CALIFORNIA INSTITUTE OF TECHNOLOGY  
Laser Interferometer Gravitational Wave Observatory (LIGO) Project

To: F. Asiri  
From: L. Jones  
Phone: 2970  
Refer to: LIGO-E950105-00-B  
Date: 12/20/95

Subject: Beam tube termination foundation: loads update

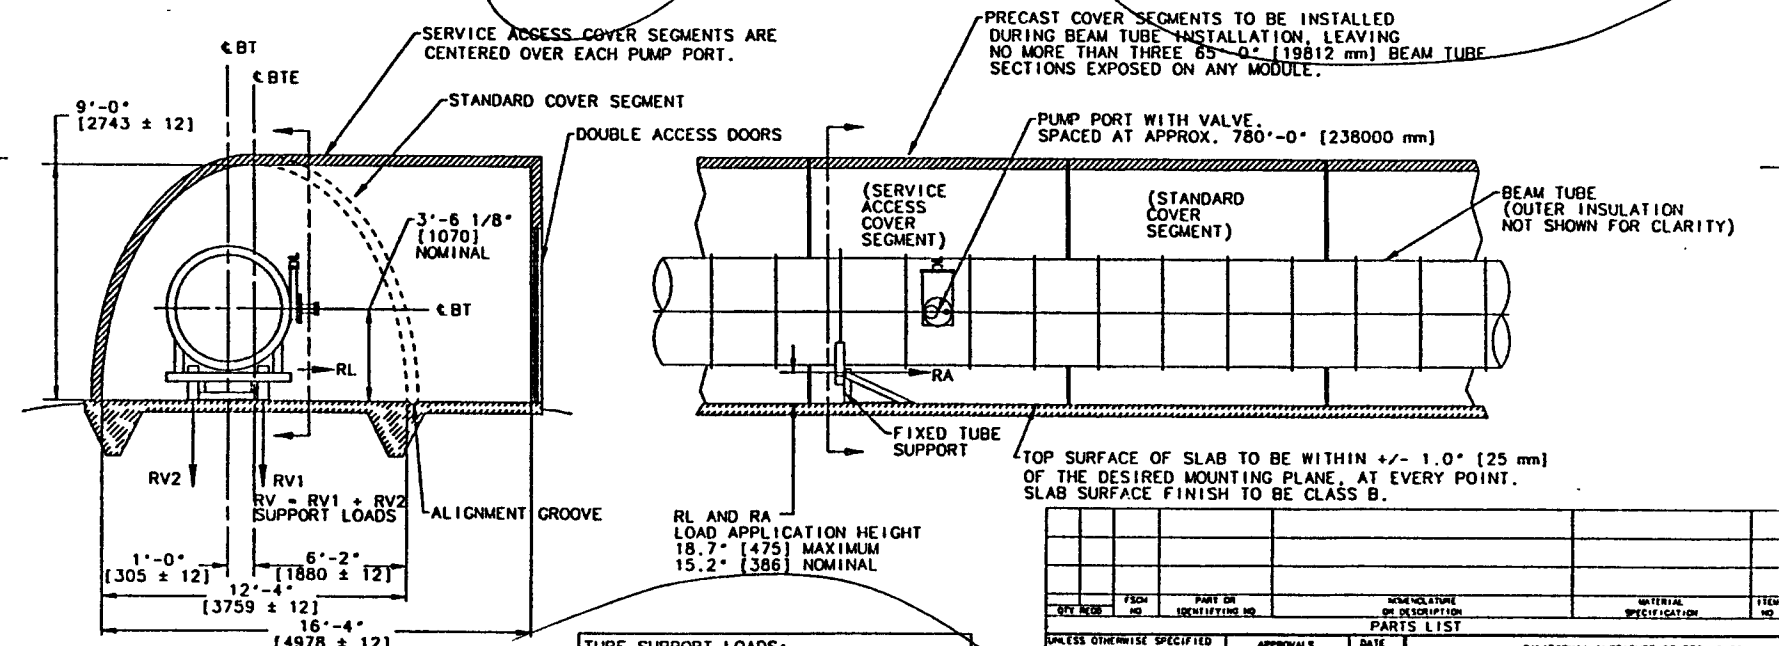
There are actually two types of load conditions for the fixed support shown on D950029. Most of the fixed supports (all but 2) are supporting 65' long tube sections. The two outermost fixed supports are supporting shorter tube sections, which causes higher loads (from adjoining, longer tubes) during bake. These two load conditions are spelled out in the markups.

TYPE LOAD	RL	RV1 MAX.	RV2 MIN.	RV MAX.	RA
SEISMIC	1287	1689	-1689	0	2169
DEAD LOAD & VAC.	85	3870	3648	7518	771
THERMAL	0	0	0	0	<del>594</del>
SETTLEMENT	0	715	-715	1430	0
HORIZ. ALIGN.	1235	1621	-1621	0	0
<b>TOTAL</b>	<b>2607</b>	<b>7895</b>	<b>-371</b>	<b>8948</b>	<del>328</del>

AT ALL BUT THE OUTERMOST FIXED SUPPORTS

AT THE OUTERMOST FIXED SUPPORTS

MAXIMUM RL	= 2607 lbf [1183 kgf]
MAXIMUM RV1	= 7895 lbf [3581 kgf]
MINIMUM RV2	= -377 lbf [-171 kgf]
MAXIMUM RV	= 8948 lbf [4059 kgf]
MAXIMUM RA	= 328 lbf [148 kgf]

PARTS LIST		FILE	SCALE	SHEET	OF
LIGO CALIFORNIA INSTITUTE OF TECHNOLOGY MASSACHUSETTS INSTITUTE OF TECHNOLOGY		BEAM TUBE TERMINATION FOUNDATIONS	D950093	1	1

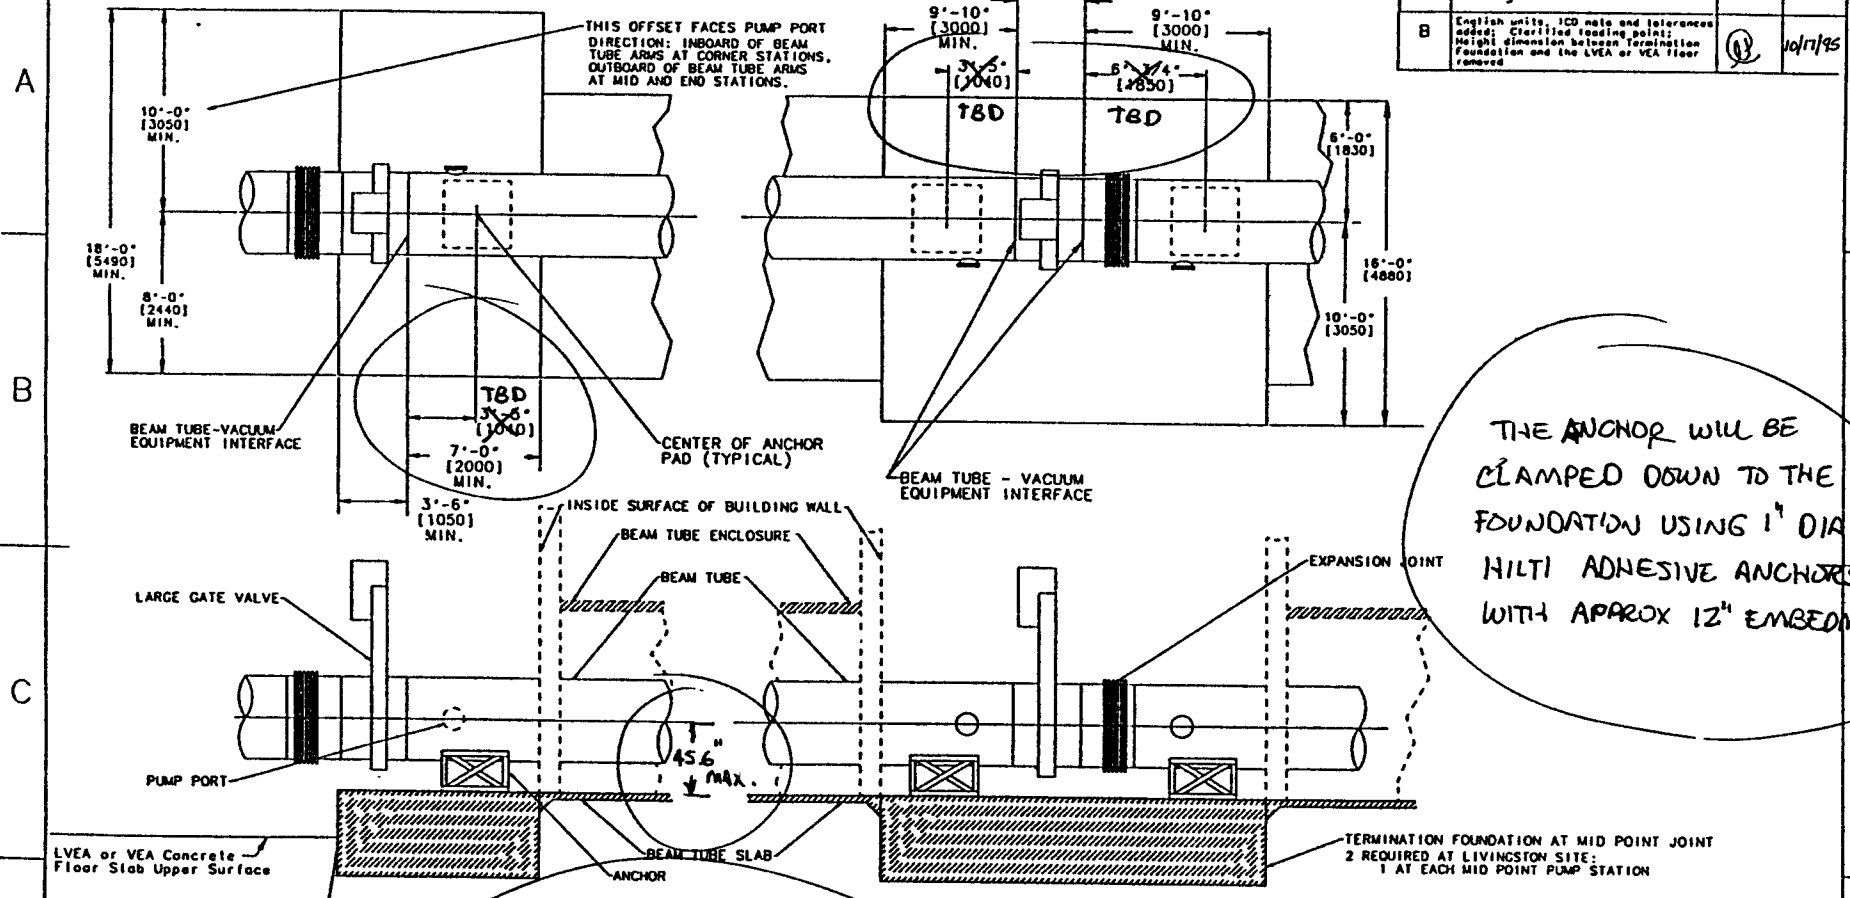
NOTE: THESE CHANGES APPLY TO REV. C OF THIS DRAWING

THE ANCHOR WILL BE CLAMPED DOWN TO THE FOUNDATION USING 1" DIA. HILTI ADHESIVE ANCHORS WITH APPROX 12" EMBEDMENT

FOUNDATION LOADS AT ANCHORS (kgf)						
DIRECTION	TOTAL	DEAD	VACUUM	SEISMIC	THERMAL	WIND
VERTICAL	3600	3600	0	0	0	0
AXIAL	18200	0	14788	854	2508	0
LATERAL	1400	0	0	696	0	704

FOUNDATION LOADS AT ANCHORS (lbf)						
DIRECTION	TOTAL	DEAD	VACUUM	SEISMIC	THERMAL	WIND
VERTICAL	7937	7937	0	0	0	0
AXIAL	40424	0	32602	1883	5639	0
LATERAL	3086	0	0	1534	0	1552

58,485 2  
 24,000
